CITY PLAN COMMISSION REPORT

Redwood MPD at N Ambassador

4 CD-CPC-2021-00231
Rezoning to UR/MPD

Plan Conditions, Corrections, & Recommendations Report

SITE PLAN

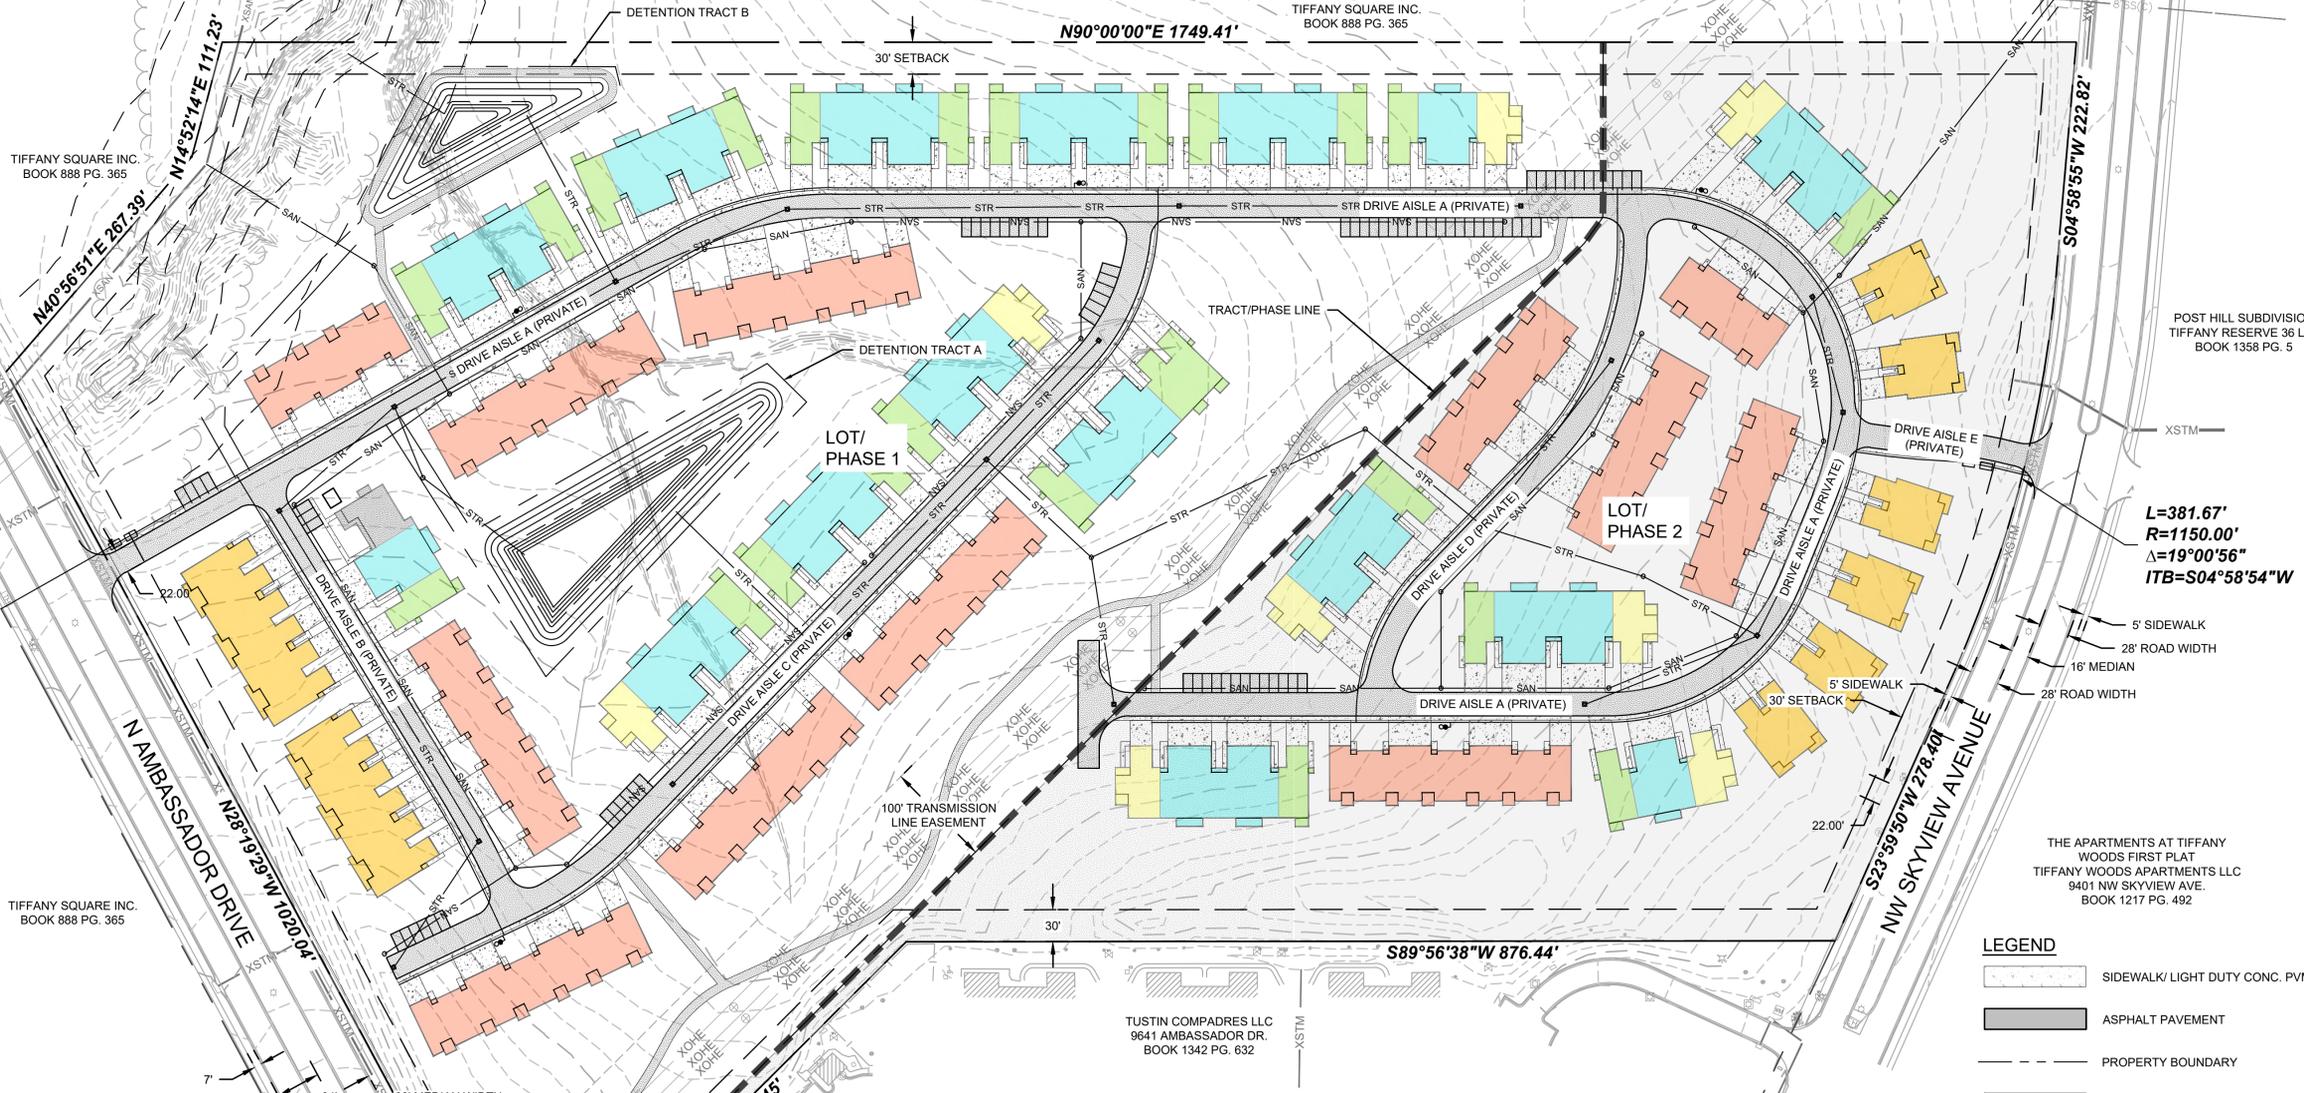
1. Site plan does not clearly show which proposed utilities are public versus private, including storm water and sanitary sewer lines. Update the site plan to clearly indicate ownership and show easements where necessary for all public lines. (1/19/2022)
2. Clarify the preliminary plat sheet to clearly designate the proposed lot and tract boundaries for staff review. If any of the stormwater detention facilities are intended to serve more than a single lot, the facility needs to be located within its own tract. (1/19/2022)
3. Clearly indicate on the proposed site plan if any median modifications are intended as part of this project along either N Ambassador Drive or NW Skyview Avenue. (1/19/2022)
